ECE/TRANS/WP.29/GRE/2009/23
16 January 2009

World Forum for Harmonization of Vehicle Regulations

Proposal for draft 01 series of amendments to Regulation No. 123
(Adaptive front-lighting systems)

Submitted by the expert from the Working Party "Brussels 1952" */

Figure 1

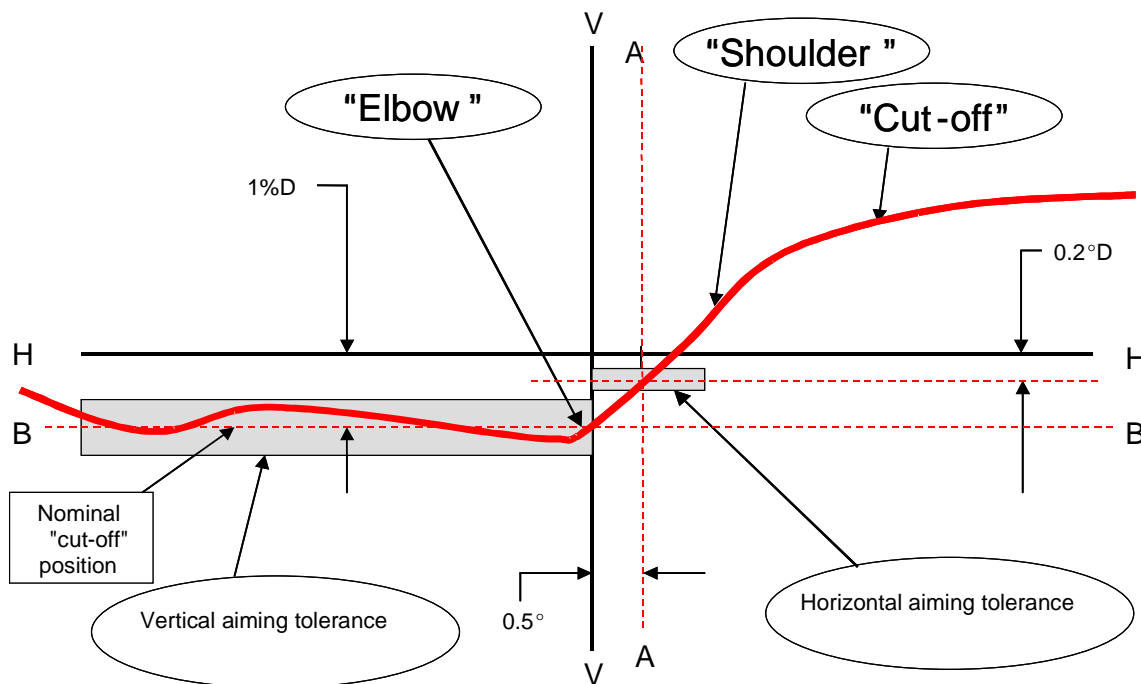
"2.2. The beam shall be **visually aimed by means of the "cut-off" (see figure 1 below).** **The aiming shall be carried out using a flat vertical screen set up at a distance of 10 m or 25 m (as indicated in section 9 of Annex 1) forward of the headlamp and at right angles to the H-V axis. The screen shall be sufficiently wide to allow examination and adjustment of the "cut-off" of the passing beam over at least 5° on either side of the V-V line.**

- 2.3. for vertical adjustment: the horizontal part of the "cut-off" is moved upward from below line B and adjusted to its nominal position one per cent (25 cm) below the H-H line;

Note: The scales are different for vertical and horizontal lines."

Figure 1: Measurement of "cut-off" quality

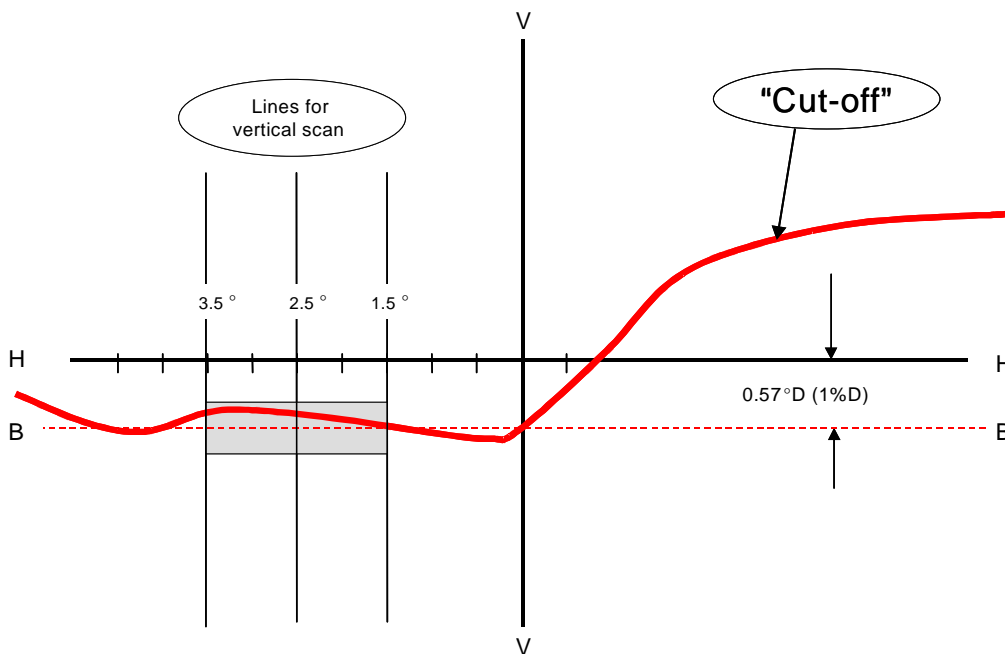
"3. VERTICAL AND HORIZONTAL ADJUSTMENT

If the "cut-off" complies with the quality requirements of paragraph 2. of this annex, the beam adjustment may be performed instrumentally.

Figure 2: Instrumental vertical and horizontal adjustment- horizontal line scan method

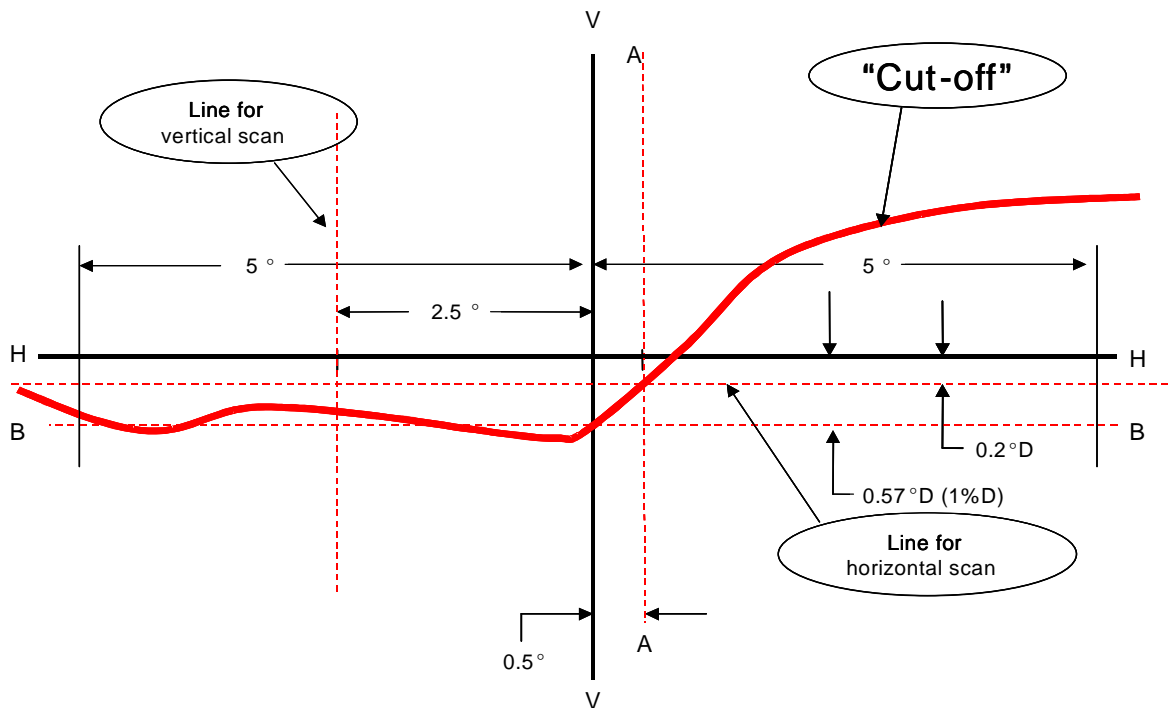
- (a) The "0.2 D line" method (see figure 2 below).

A single horizontal line at 0.2° D shall be scanned from 5° left to 5° right after the lamp has been aimed vertically. The maximum gradient "G" determined using the formula $G = (\log E_{\beta} - \log E_{(\beta + 0.1^\circ)})$ where β is the horizontal position in degrees, shall not be less than 0.08.

The inflection point found on the 0.2 D line shall be positioned on the line A.

Figure 3: Instrumental vertical and horizontal adjustment-three line scan method "

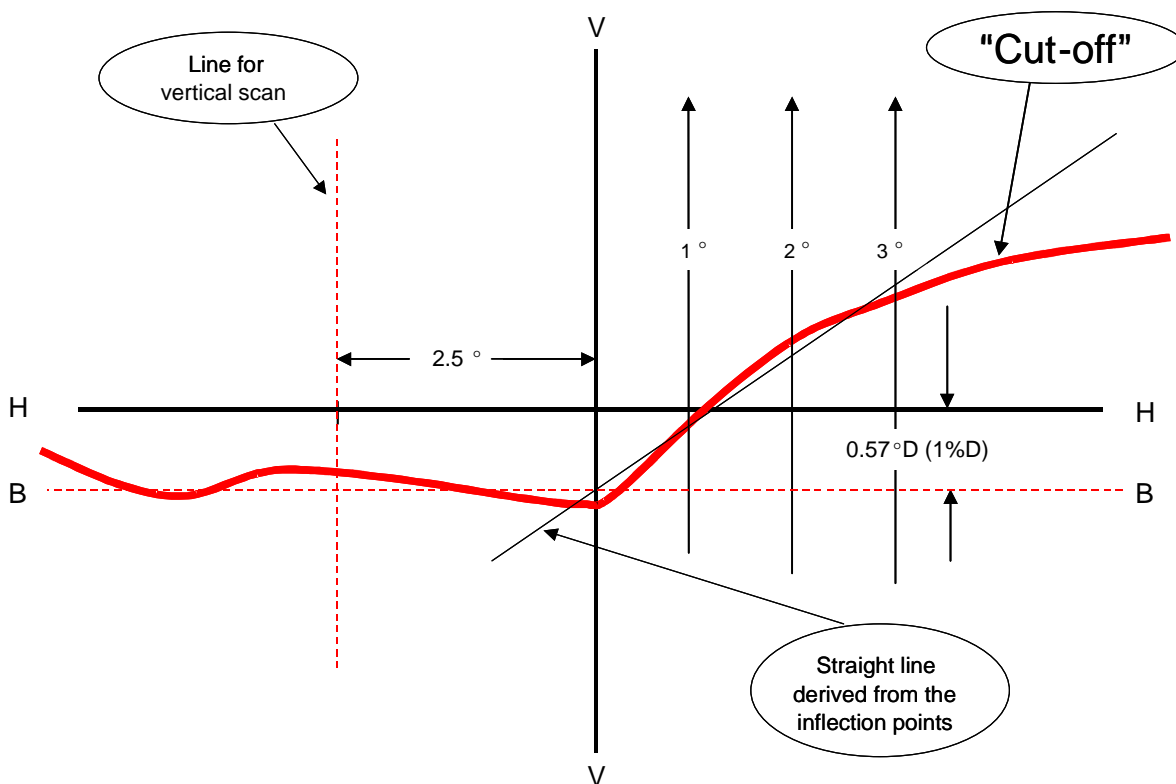
(b) The "3 line" method (see figure 3 below)

Three vertical lines shall be scanned from 2° D to 2° U at 1°R, 2°R, and 3°R after the lamp has been aimed vertically. The respective maximum gradients "G" determined using the formula:

where β is the vertical position in degrees, shall not be less than 0.08. The inflection points found on the three lines shall be used to derive a straight line. The intersection of this line and the line B found while performing vertical aim shall be placed on the V line.

Diagram 1 "

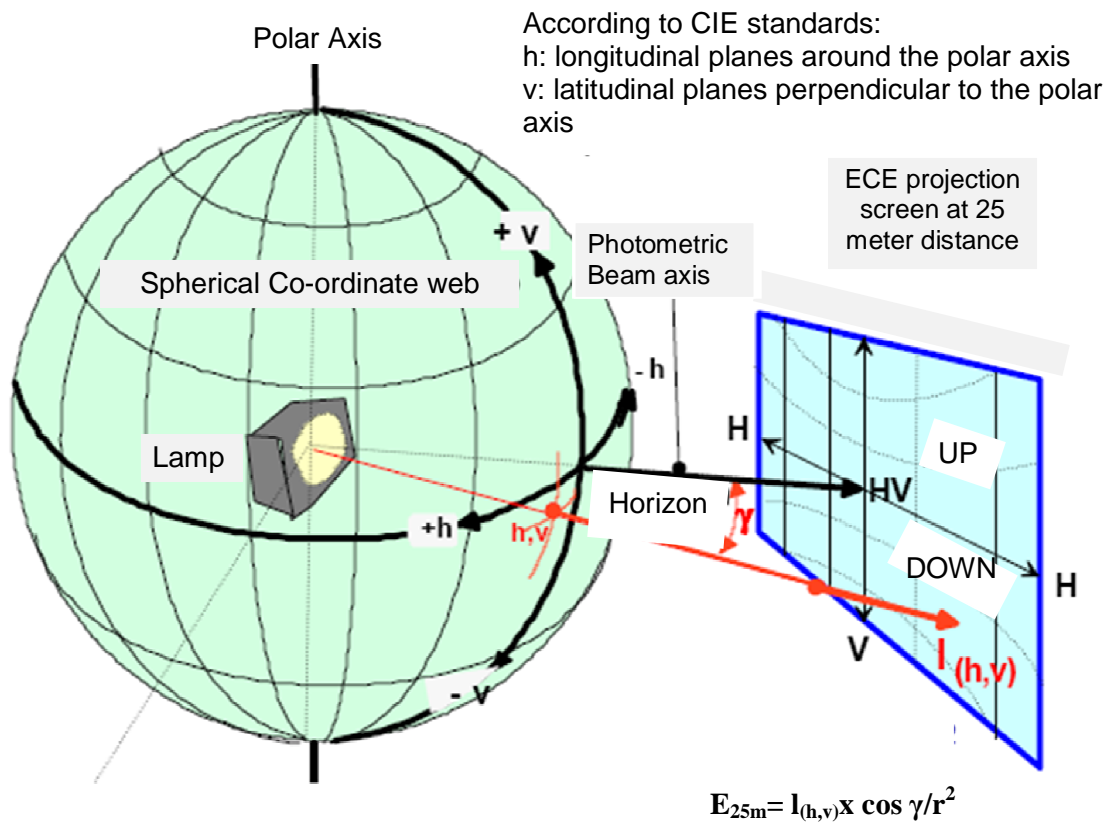
Paragraph 1.5., insert diagram1 and amend to read:

"1.5. The angular co-ordinates are specified in deg on a sphere with a vertical polar axis according to CIE publication No. 70, Vienna 1987, i.e. corresponding to a goniometer with a horizontal ("elevation") axis fixed to the ground and a second, moveable ("rotation") axis perpendicular to the fixed horizontal axis. (See **diagram 1**)"
